## Product Change Notification

**PCN#:** 466

**Change Title:** Product End of Life (EOL)

End of Life for the FPXLF series.

### HC49SPXLF

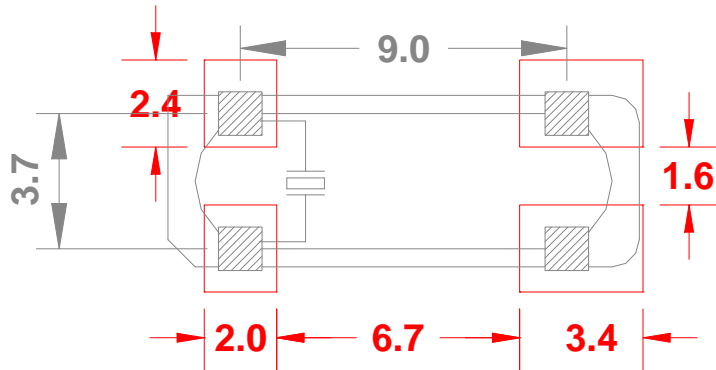
Primary suggested substitution.  
(Matches FPXLF recommended solder pad layout.)

### FQ5032A

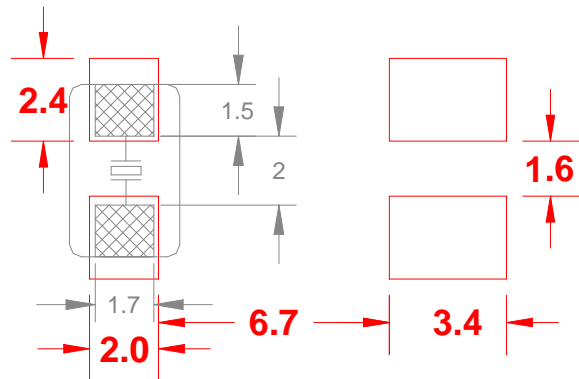
Alternative 2 pad substitution.  
(Connects to active crystal pads.)
